Access Compliance Report Public Rights-of-Way (Curb Ramps)

Main Street: WESTCOTT_LN Cross Street: LIVINGSTON_PL Location: NW

ADA ID: RPRK211026125549 Ramp Type: Type 4 - Parallel Initial Pass/Fail: Fail Overall Compliance: No Severity Score: 2

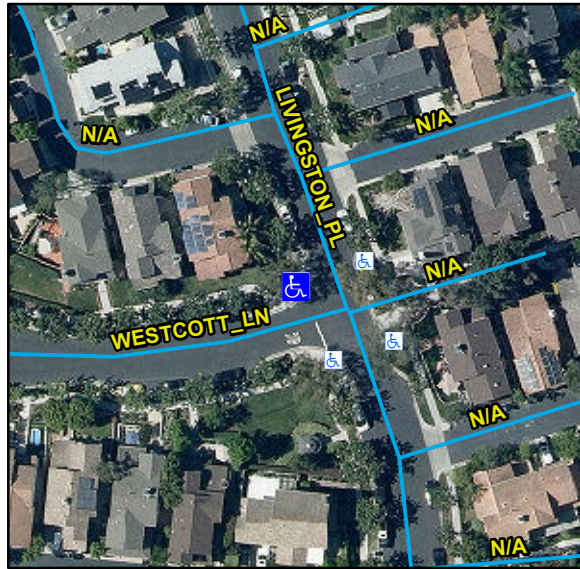
Compliance	Description	Data	Compliance	Description	Data
N/A	Ramp Length LT (in)	113	N/A	Ramp Length RT (in)	116
Yes	Ramp Width LT (in)	53	Yes	Ramp Width RT (in)	52
Yes	Ramp Run Slope LT (%)	5.8	Yes	Ramp Run Slope RT (%)	4.4
Yes	Ramp Cross Slope LT (%)	0.6	No	Ramp Cross Slope RT (%)	2.4
N/A	Landing Present	N/A	N/A	DWS Provided	N/A
N/A	Landing Length (in)	N/A	N/A	DWS Contrast	N/A
N/A	Landing Width (in)	N/A	N/A	DWS Length (in)	N/A
N/A	Landing Run Slope (%)	N/A	N/A	DWS Full Width	N/A
N/A	Landing Cross Slope (%)	N/A		DWS Offset Type	N/A
N/A	Landing Movement Obstructed?	N/A	N/A	DWS Offset Left (in)	N/A
	Landing Movement Type	N/A	N/A	DWS Offset Right (in)	N/A
N/A	Landing Shared	N/A			
N/A	Clear Space	Yes			
N/A	Clear Space To Crosswalk (in)	N/A			
N/A	Marked Crosswalk 1	No	N/A	Marked Crosswalk 2	No
	Crossing 1 Direction	S		Crossing 2 Direction	E
	Marked Crosswalk 1 Width (in)	N/A		Marked Crosswalk 2 Width (in)	N/A

Remove & Replace Curb Ramp With Two New Directional Ramps or Equivalent.
